DEVELOPMENT APPLICATION
New Independent Living Units
95 Stanhope Road, Killara
For Aevum Limited

TITLE Southwest - Basement + Roof Plan
SCALE 1:100 @ A1
DATE 15.10.10
DRAWN JK/CKH
CHECKED PT
0 1 5 10 metres

DWG NO
DA2.1

ISSUE **DATE** **AMENDMENT**
DA 25.06.10 For inclusion in Development Application
B 15.10.10 Council request for additional information
C 28.01.11 Council request for additional information

1 SW Basement Plan
1:100 @ A1

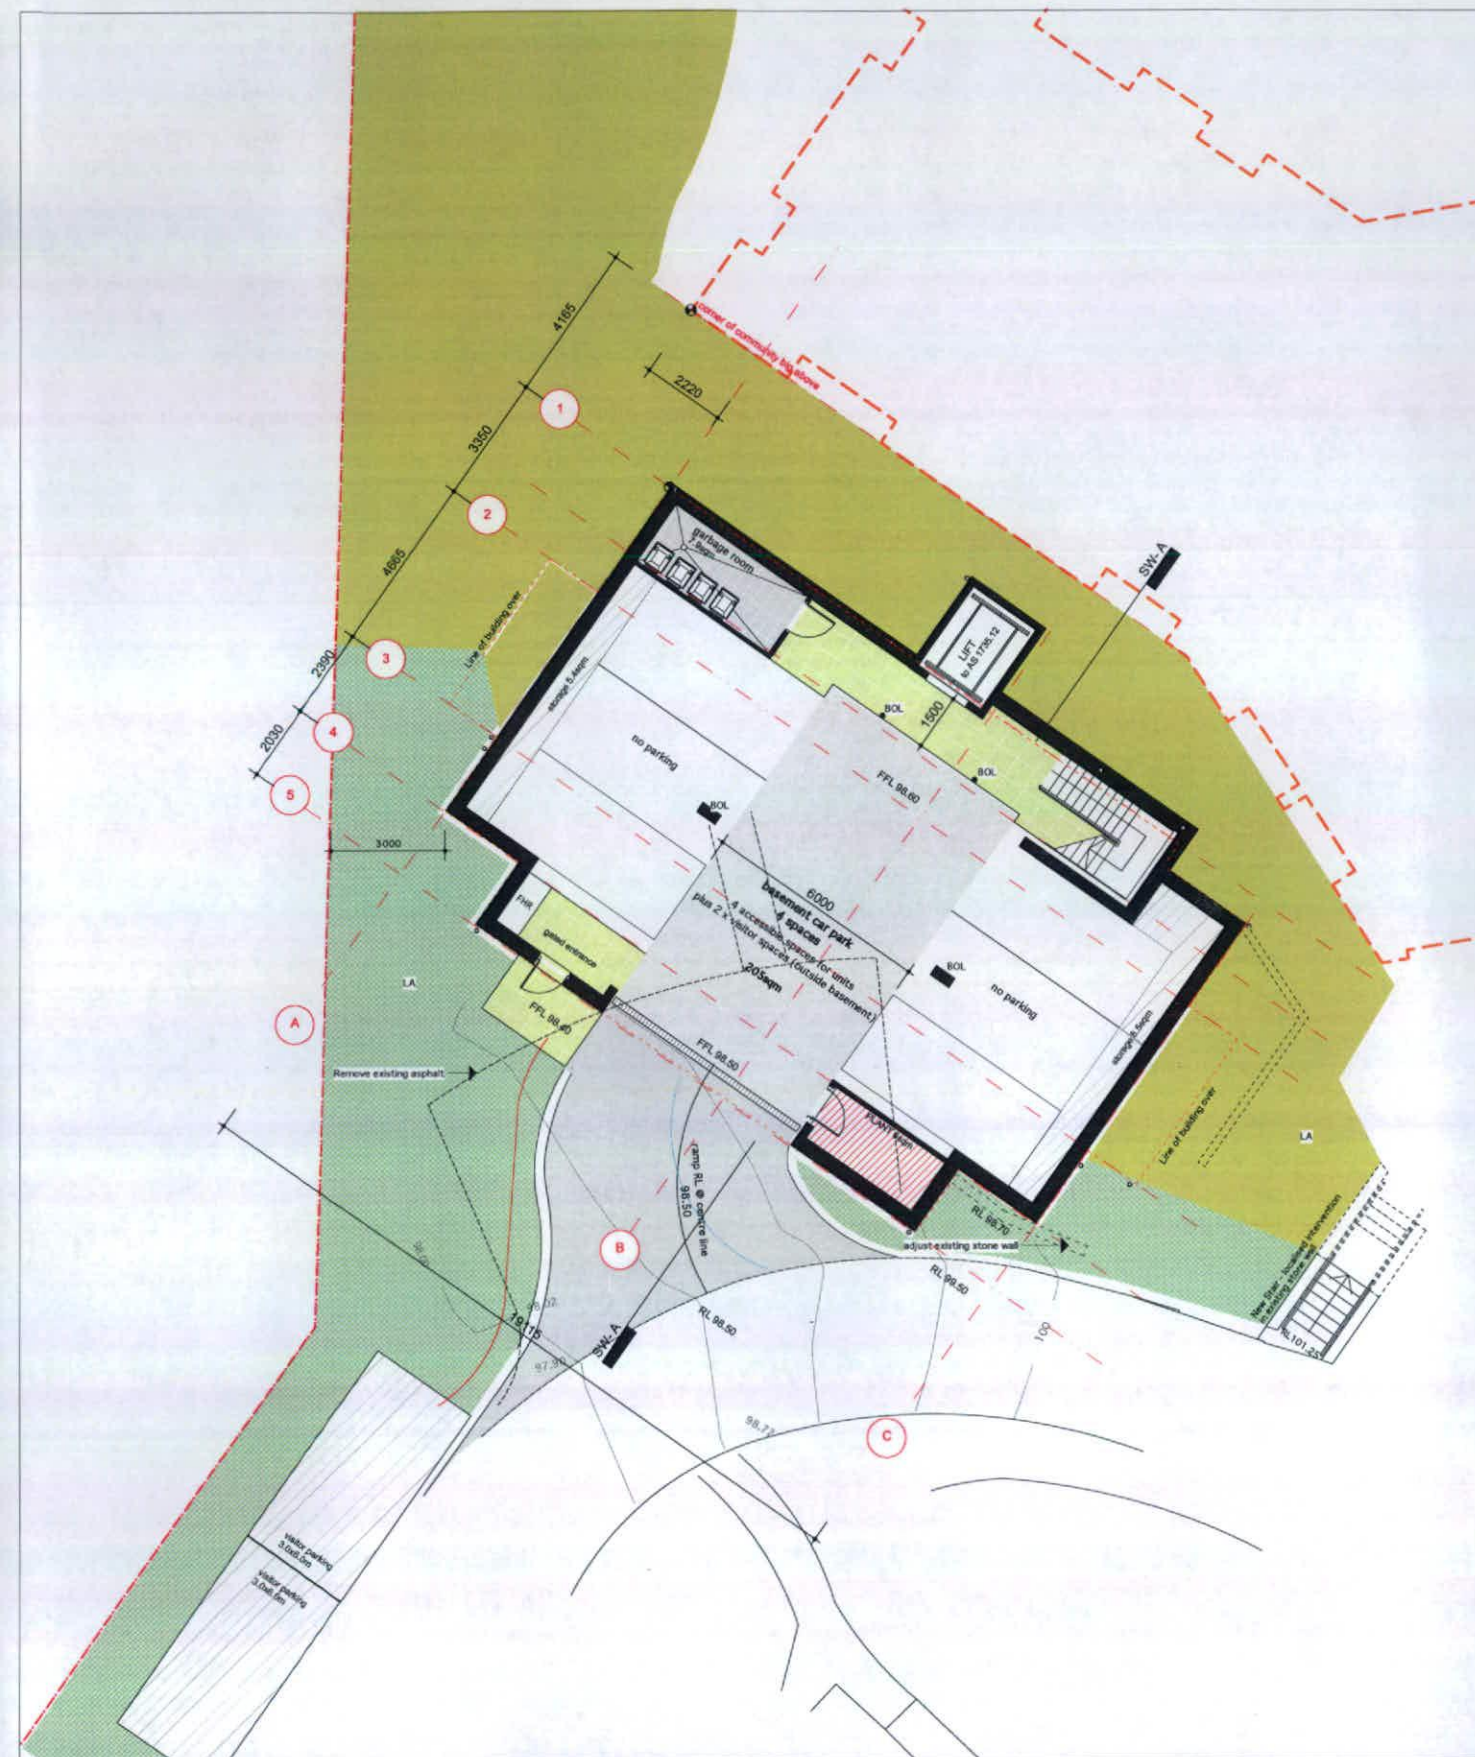
RECEIVED
18 OCT 2010
Amendments
1. Balconies extended

1 SW Ground Plan
1:100 @ A1

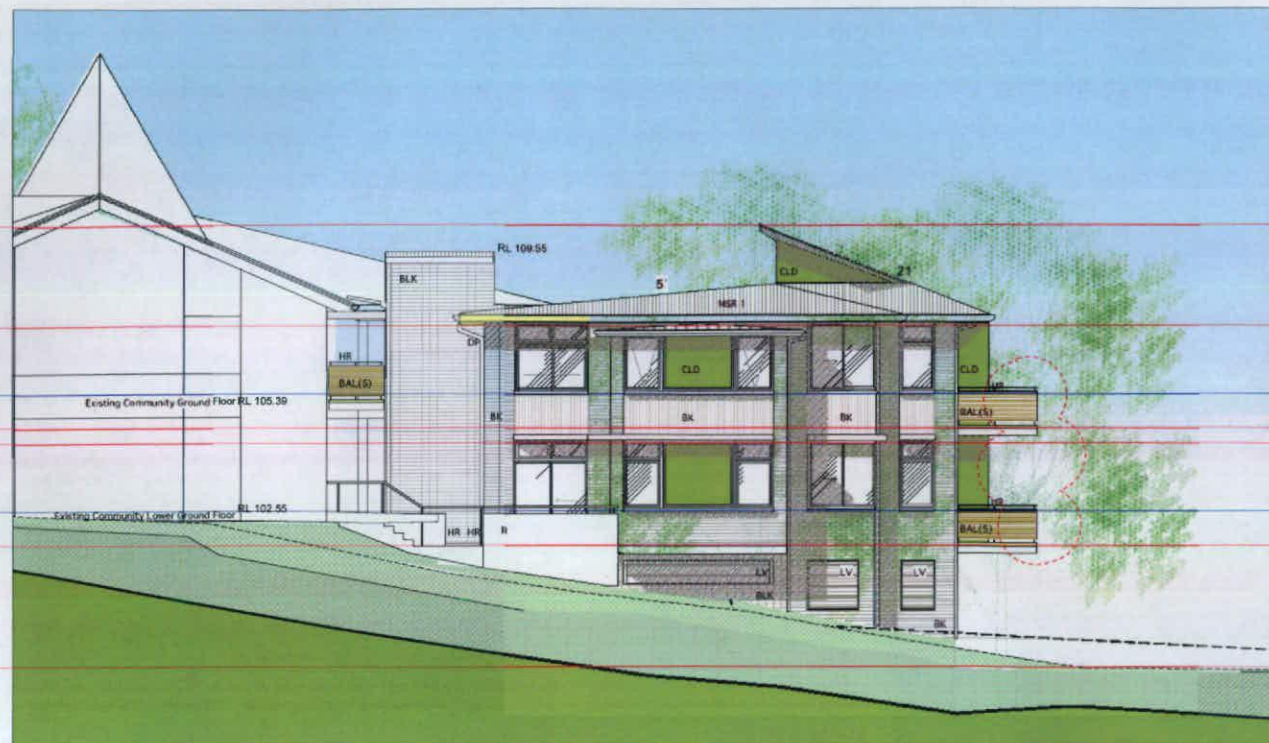
- Amendments
- 1. Balconies extended
 - 2. Lockable letter boxes added
 - 3. Entrance door accessible compliant
 - 4. Kitchen has a wall oven added
 - 5. laundries moved to allow entrance door to move
 - 6. Acoustic compliance note added.

1 Level 1 Plan
1:100 @ A1

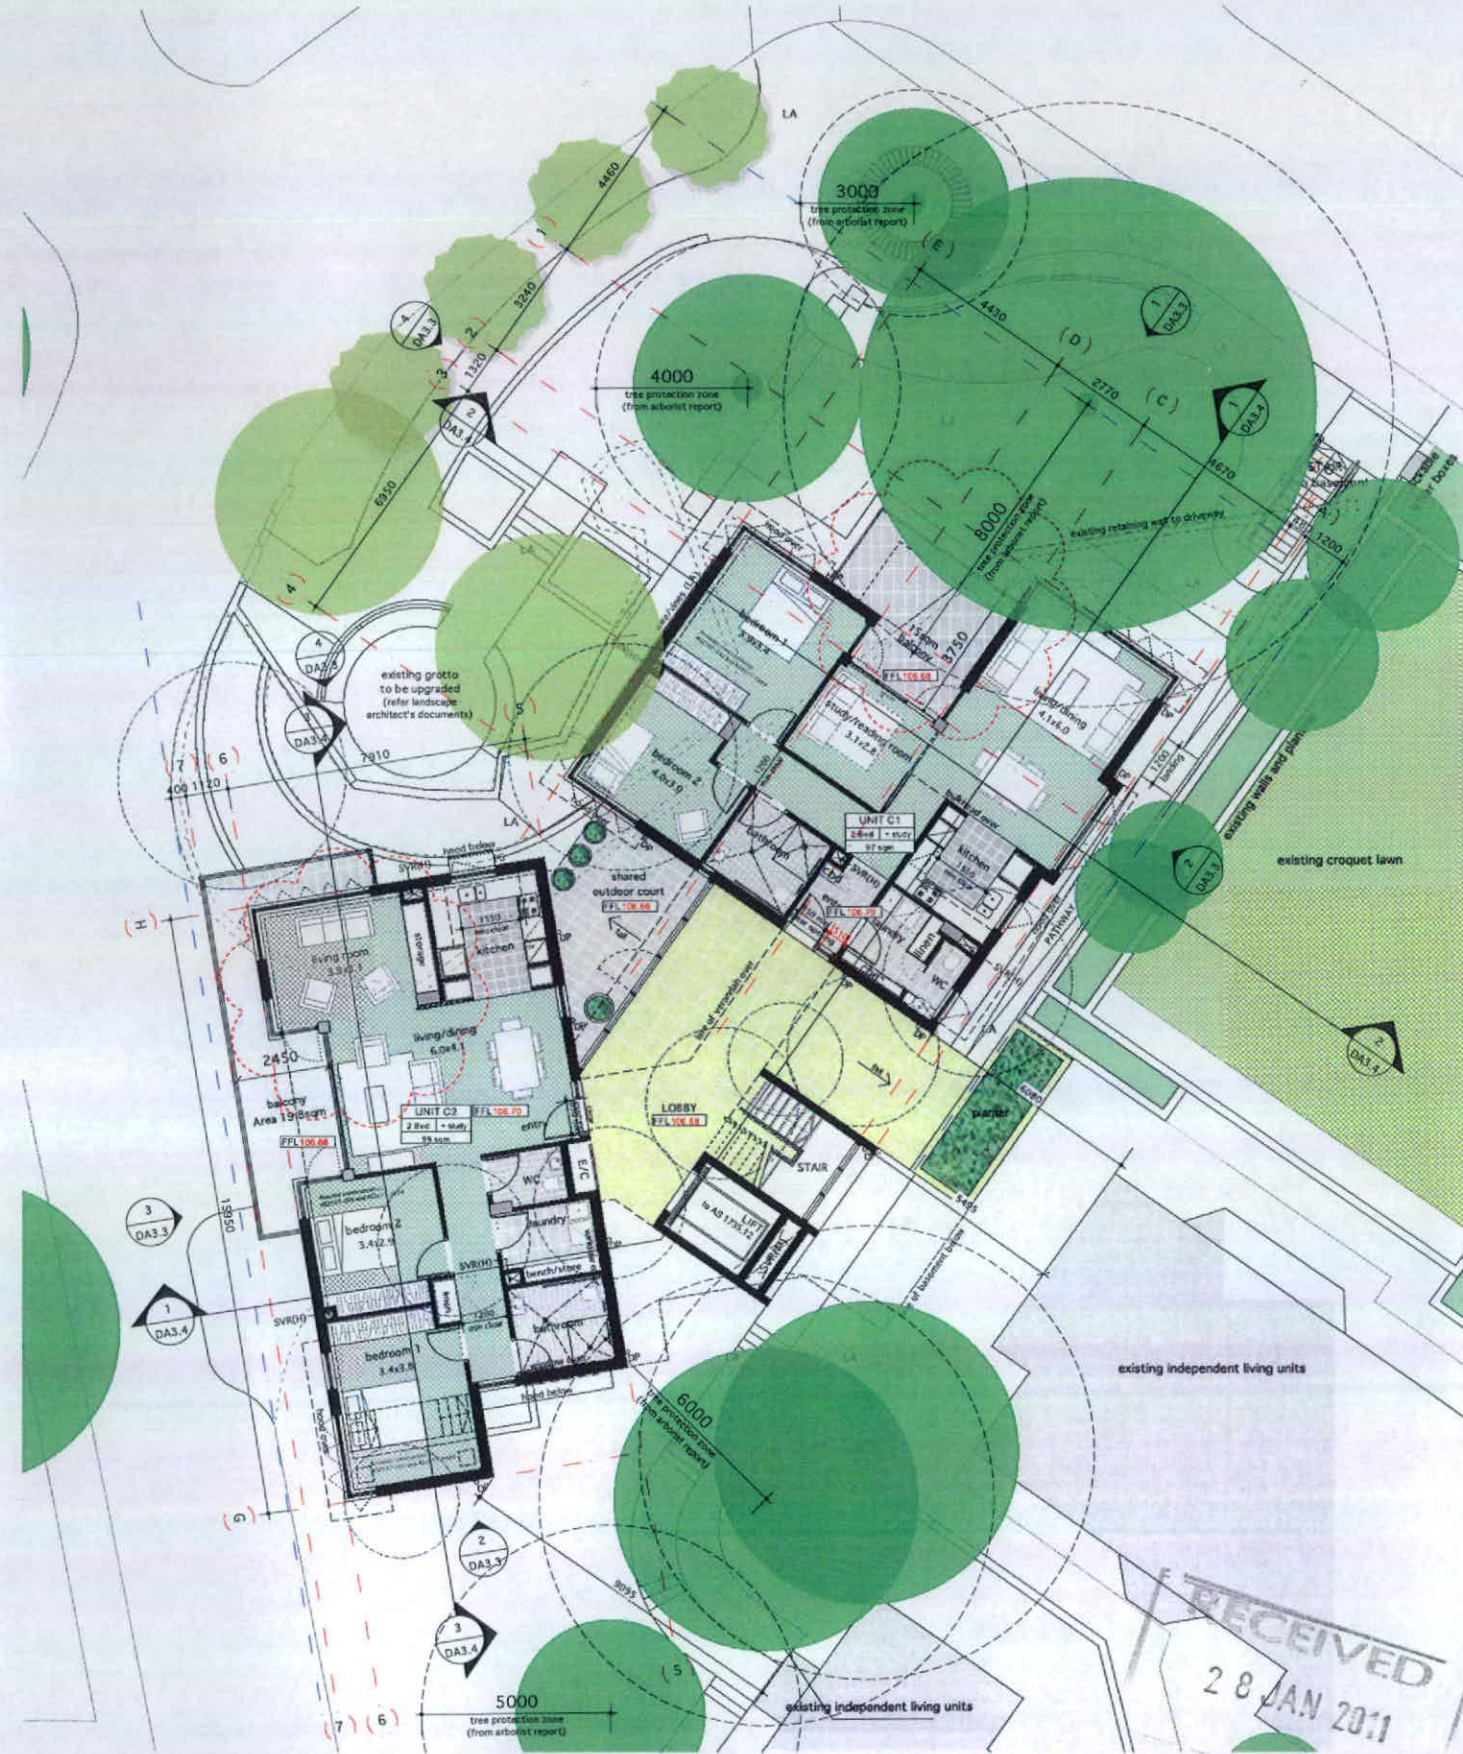
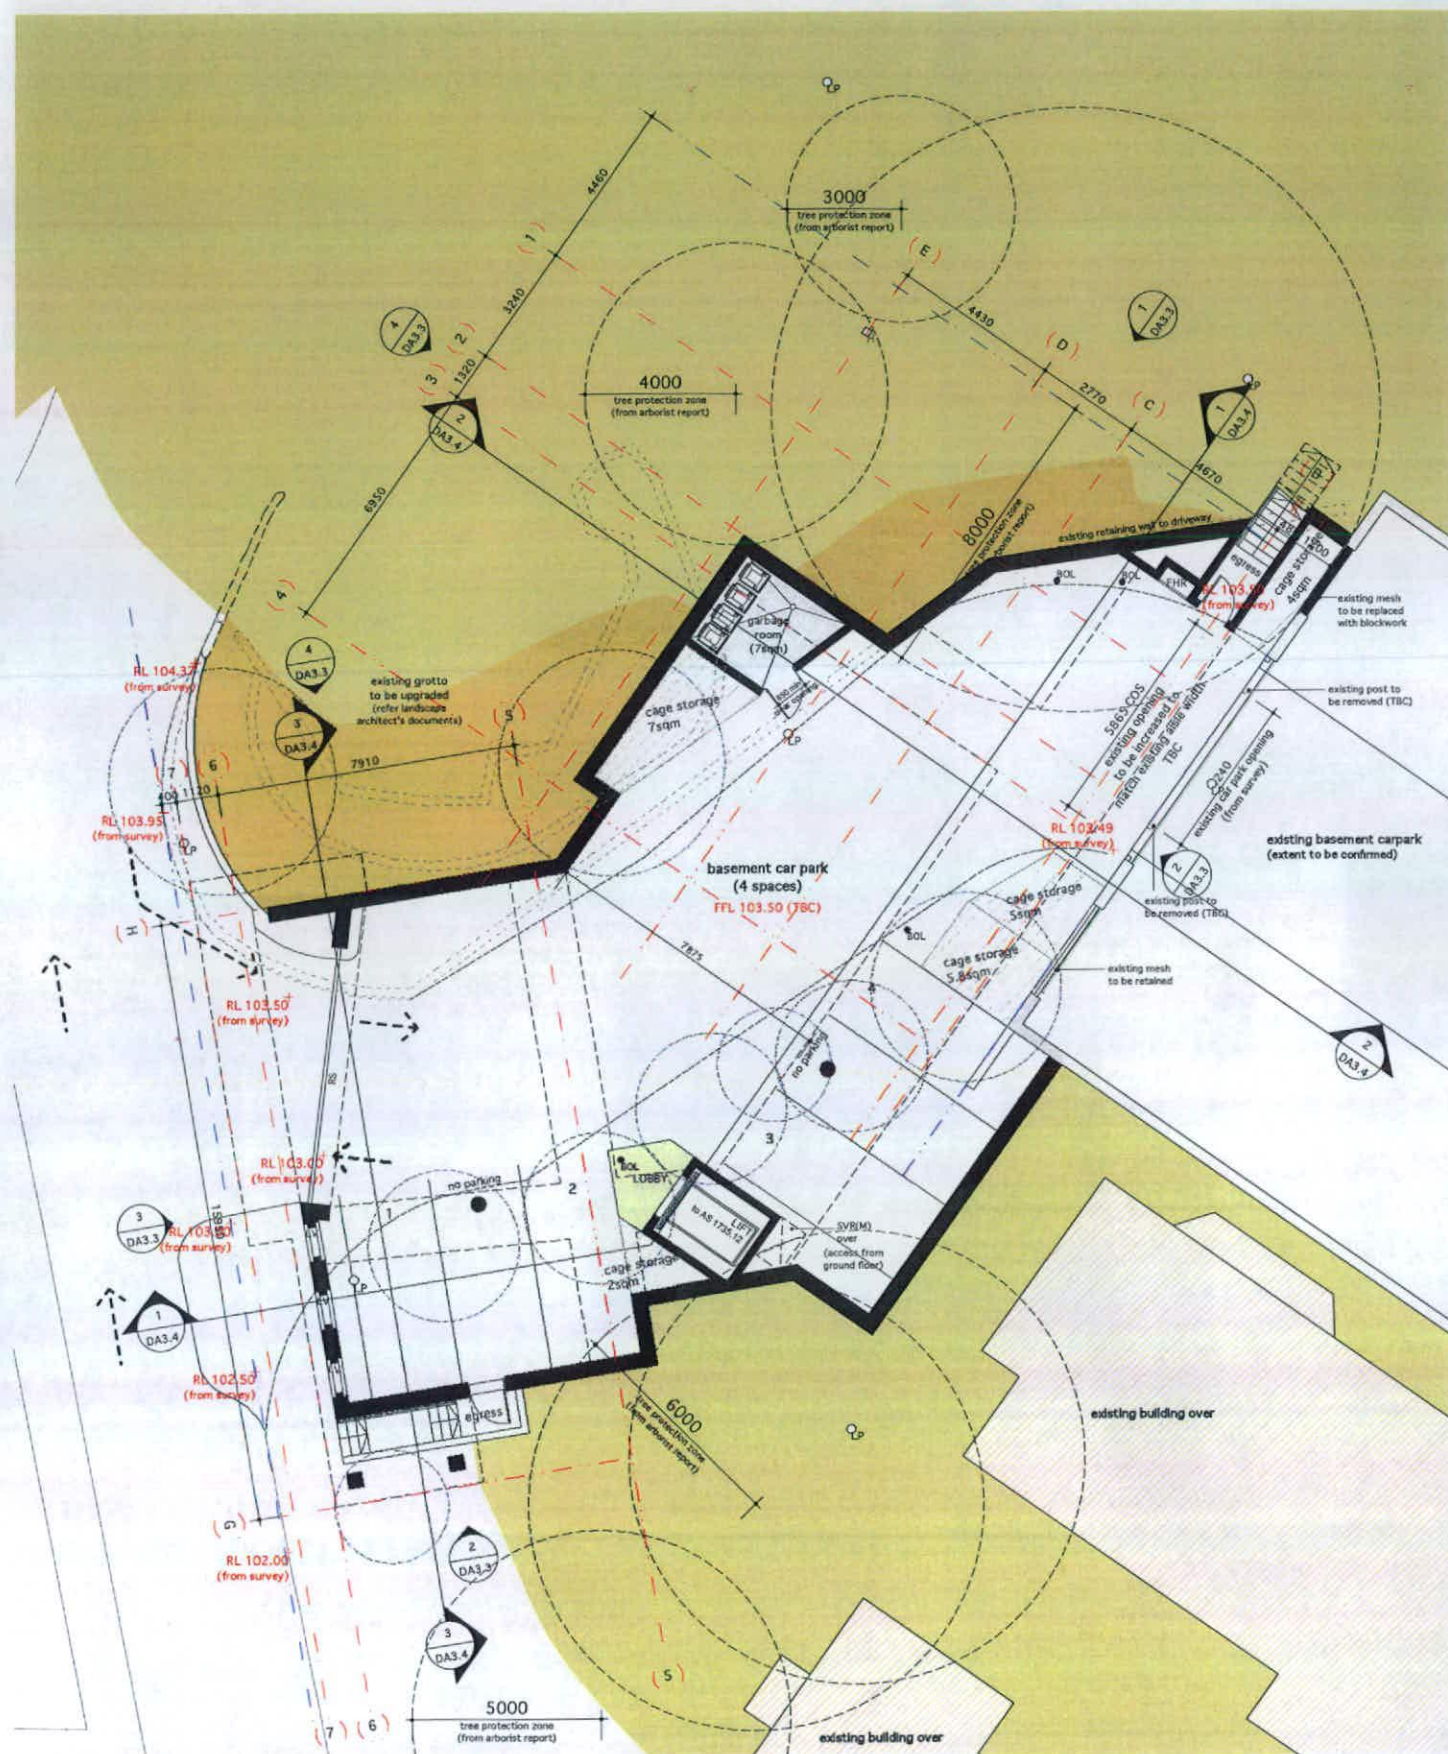
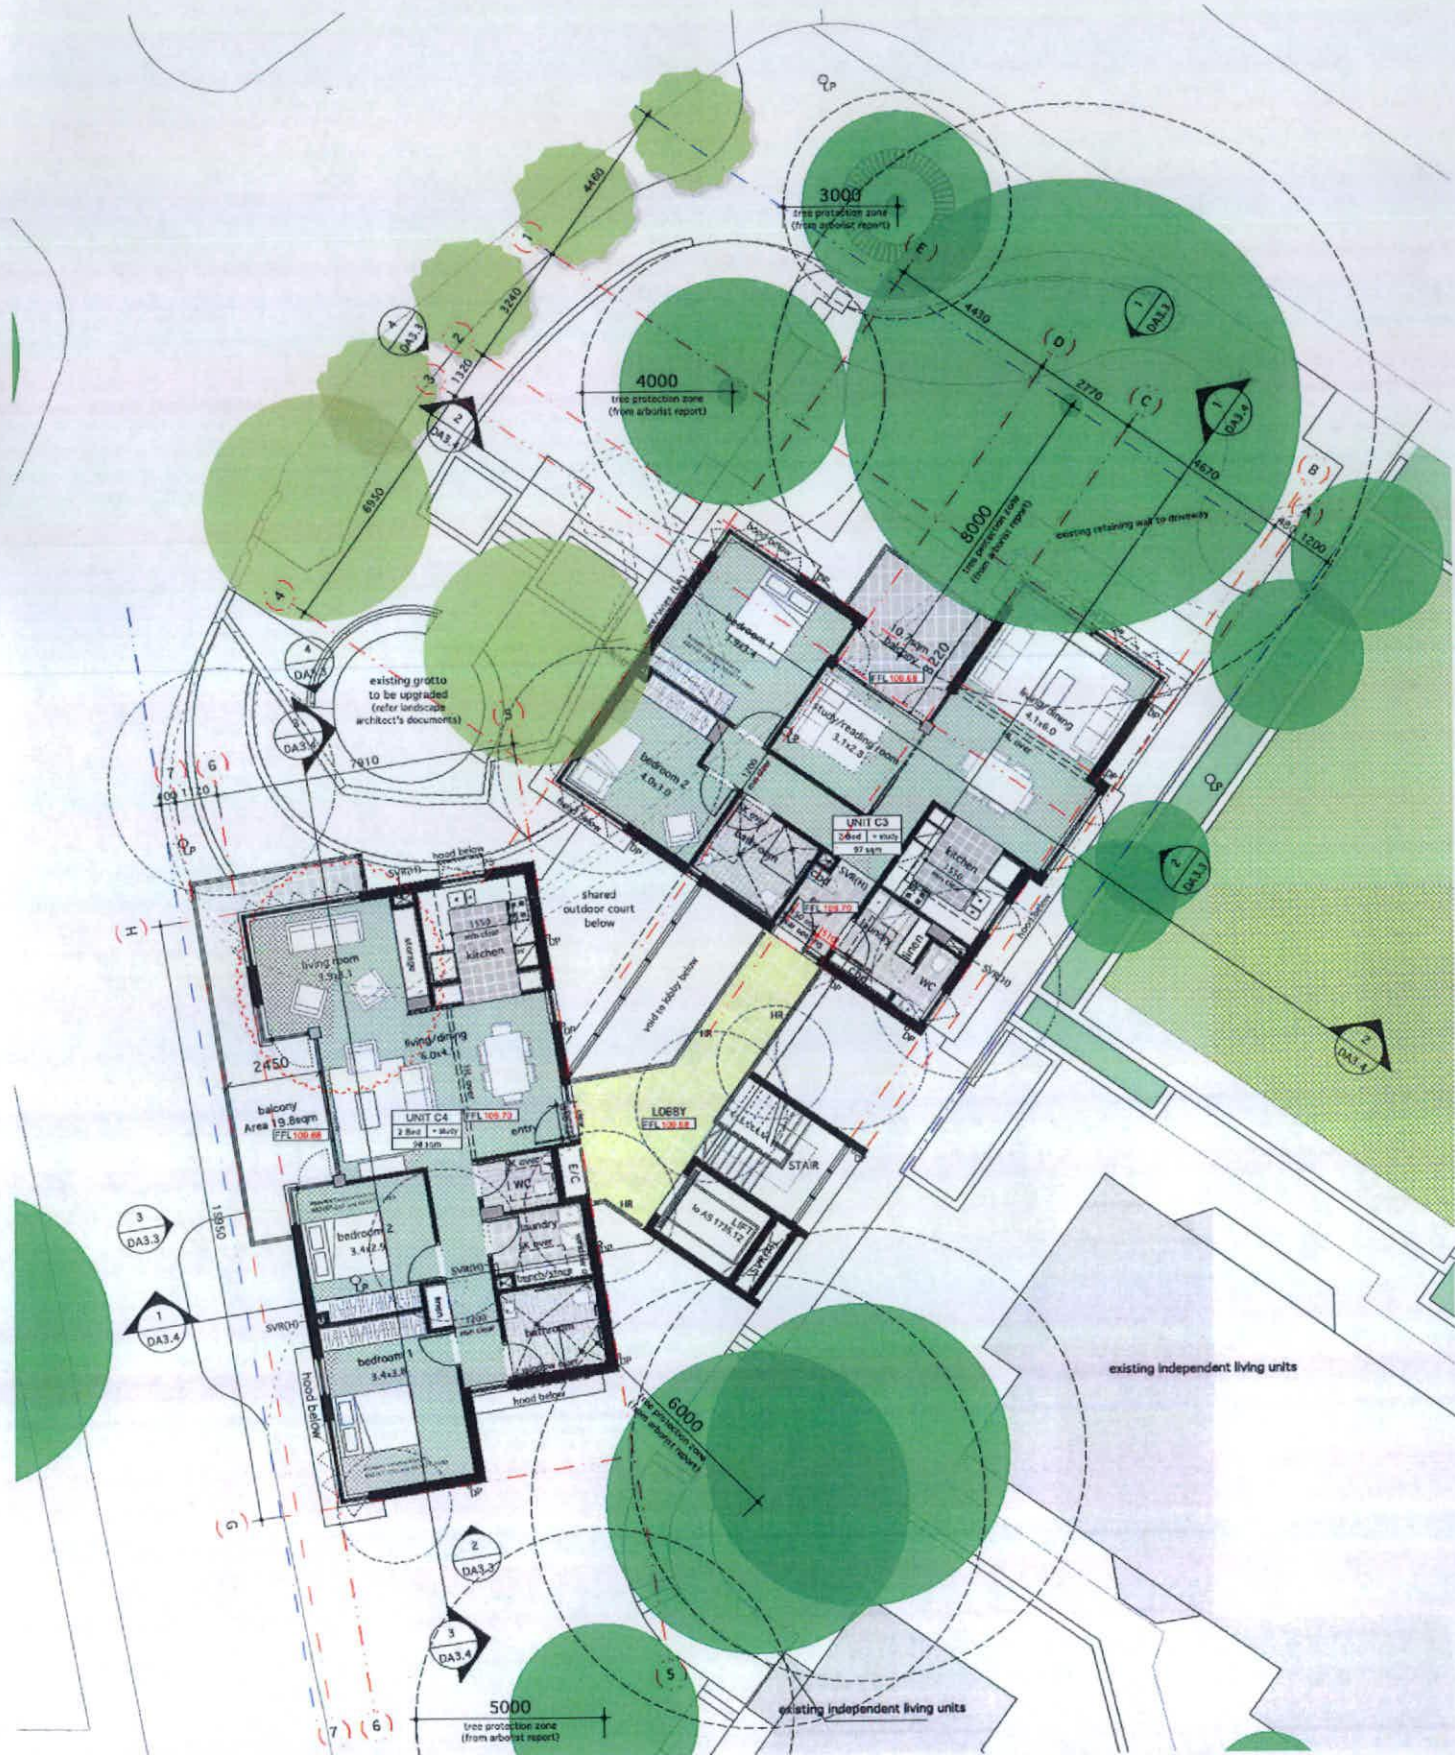
Amendments
1. Balconies extended

1. Unit C1 enlarged balcony
2. Unit C2 plan revised to open plan living

Amendments Ground level
1. Unit C2 plan revised to open plan living
